PITEAU ASSOCIATES

Our file: 87-975C

November 6, 1991

Re: Geotechnical Review of Aurora Pit

PHOTO 1. West failure on south wall. Note cracks on 7100 berm.

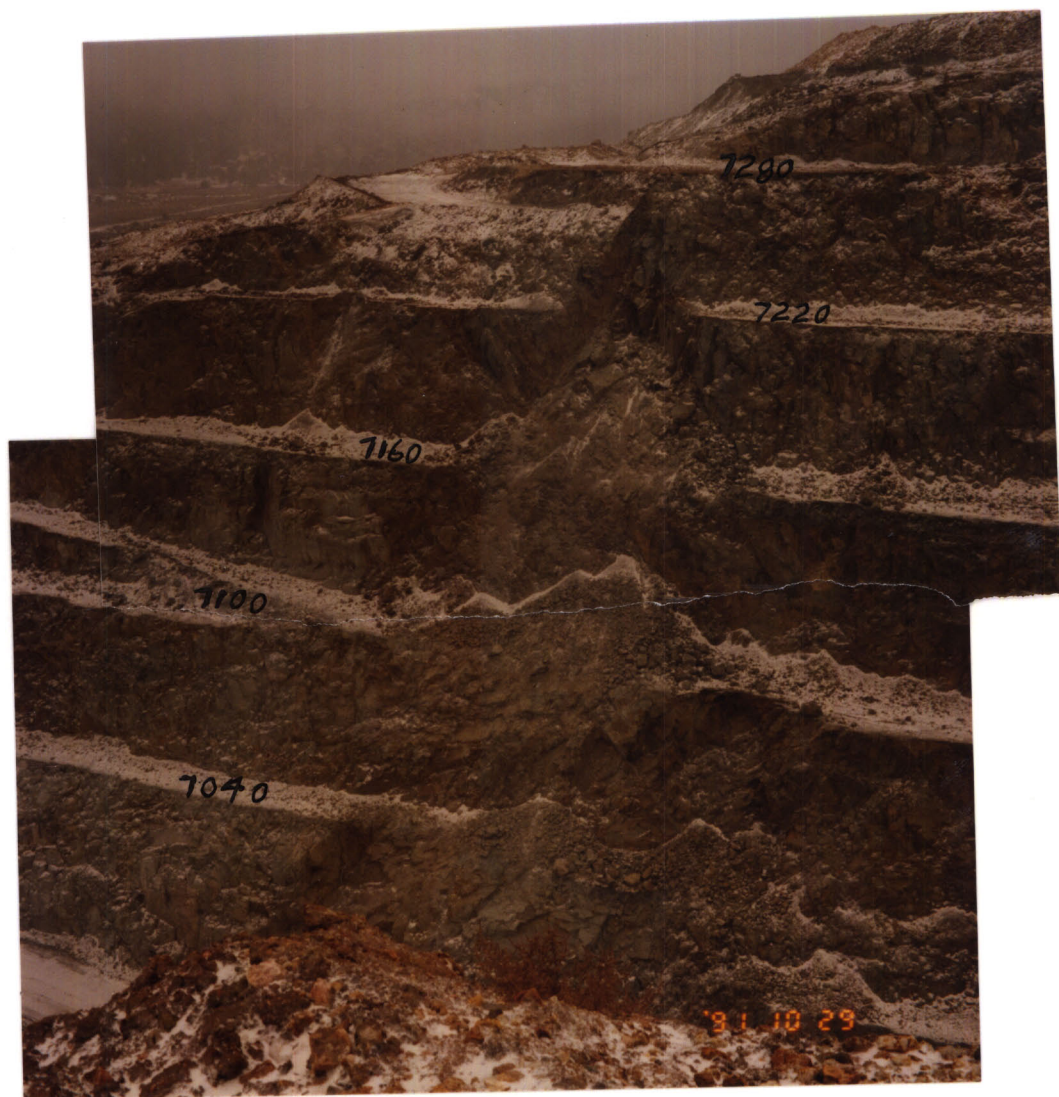
This failure is located between the 7100 and 7020 ft elevations in the vicinity of 14125N and 9500E, just east of the north wall failure discussed in our report of May 17, 1991 (see Photo 1). The failure appears to be an extension of the May 1991 failure. That is, the rock that is failing is part of or immediately in front of a major fault zone that strikes approximately N80E and dips near vertical, intersecting the south wall at a slightly oblique angle. The extent of the failure along the wall is about 125 ft. At the time of the site visit, a few rockfalls and general ravelling were occurring from the area. Cracks were observed on the 7100 safety berm within about 6 ft of the toe of the berm. One monitoring prism had been installed near the western end of the failure on the 7100 ft safety berm. Monitoring results indicated that for about the last month, the average movement rate of this portion of the slope has been 16mm/day (as opposed to prism movement rates of about 1mm/day). The results also indicated that this movement has tended to occur in a series of short spurts of greater magnitude, followed by relatively stable periods of little or no movement. These spurts of movement are thought to be related to blasting in the pit and possibly to weather (i.e. such as periods of heavy rainfall).

Based on the above, it is concluded that the failure area is unstable and could either continue to slowly break up or could fail as a relatively large mass. Furthermore, prism monitoring indicates that movement of the failure has increased in the last month and that blasting in the pit is probably related to the recent increased movement. Thus, given that it does not appear possible to remove the failure mass safely with the existing mining equipment, and it is considered unsafe to extend the ramp past this area, it is recommended that the area beneath the failure be bermed off and that the mining scenario described above that would allow ramping to a 6900 ft elevation pit bottom be implemented. Notwithstanding

this recommendation, it is felt that there is a strong likelihood that the failure mass will collapse on its own, and thus will be able to be removed/stabilized before mining is completed, possibly allowing the original mine plan to be accomplished (i.e. to reach the 6860 ft elevation) in the present mining phase. While it is not recommended at the present time, it may be possible to lower surface charges into the cracks at the back of the failure to try to accelerate failure of the mass. This should only be attempted if conditions are such that it can be carried out safely, and there is a high probability of success without causing further damage to the wall.

To better assess the state of stability of this area, it is recommended that a second prism be established on the 7100 safety berm towards the east end of the failure. This should only be done once safe access to this area of the 7100 berm has been re-established (i.e. after the east failure discussed below has been stabilized). Prisms should be monitored and results assessed at least every second day. Visual inspection of the failure area should be carried out on a daily basis and personnel should not be allowed in the pit bottom in the vicinity of the failure.

PHOTO 2. East failure on south wall.

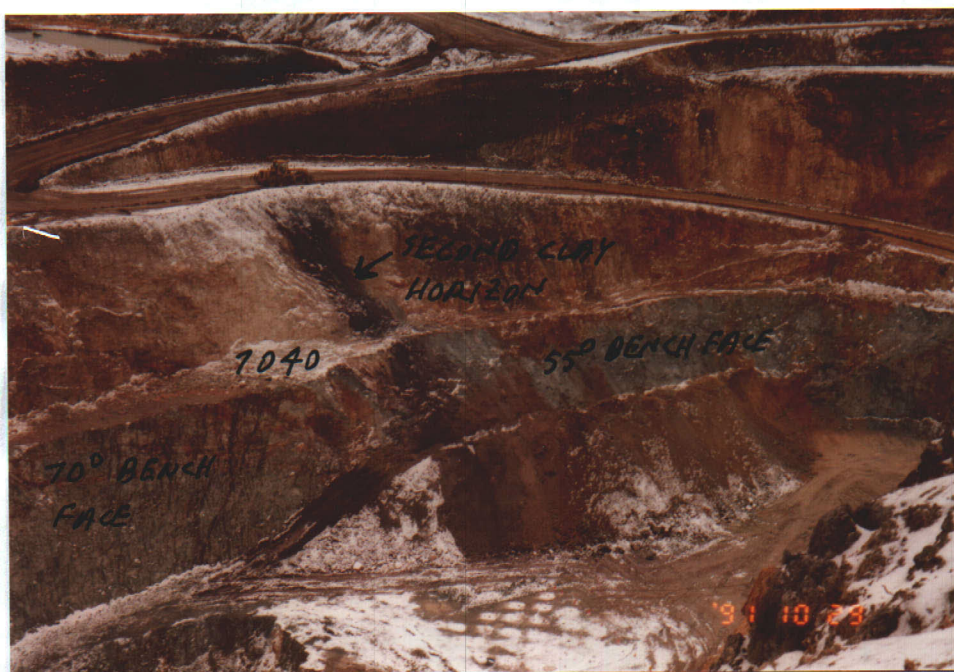
This failure area is located just east of the west failure (see Photo 2). It appears to involve primarily bench scale planar sliding on joints of Joint Set E, with lateral release/sliding on joints of Joint Sets B and D (see PAEL reports of February and November 1988 for description of joint sets). While joints of Joint Set E are observed in other areas of the south wall, they are usually relatively discontinuous and only result in breakback of bench crests. However, in this area, the joints are more frequent and more continuous, with a few being as long as about 50 ft.

At the time of the site visit, the failure had broken back to the pit crest at the 7280 ft elevation, with some cracking appearing near the toe of the 7280 berm. Most of the berm width below the crest in this area had either been filled with rubble or had been lost due to breakback of the individual bench crests. Rockfall and raveling activity was occurring sporadically from above the 7160 ft elevation.

While the above described failure represents an immediate hazard to men and equipment operating underneath it, in that any rockfalls are likely to reach the pit bottom, it is concluded that the slope should be able to be stabilized to an acceptable level. In this regard, and as there is ready access to the top of the slope, it is recommended that an initial 20 ft high cut be taken from the crest of the slope between the 7280 and 7260 ft elevations. This will remove a significant amount of unstable fractured

and loosened rock from the crest area. The slope should then be inspected and, if necessary, a second, and possibly a third, 20 ft high cut of rock should be removed. At each step, any loose material should be scaled from the slope with the backhoe (which can reach about 20 ft below the level on which it is working). Once this is completed, the slope should be inspected to determine if there are any potential rockfalls that are still hanging up on the slope. If such potential rockfalls exist, and assuming that they can be safely accessed, it would be advisable to attempt to hand scale them from the slope. Such work should be done from the top of the slope downward, and only if the slope above where men are working has been satisfactorily scaled of all loose material. Extreme caution should be used at all times when carrying out this work.

As soon as possible following the above remedial work, at least three prisms should be established on the 7280 ft level, with at least one prism being installed behind the crack on the 7280 level. At least daily visual inspections should be carried out in this area while men and equipment are working on or below the slope. Depending on the results of such monitoring and inspection, additional scaling or the installation of additional prisms or possibly crack monitors may also be required.
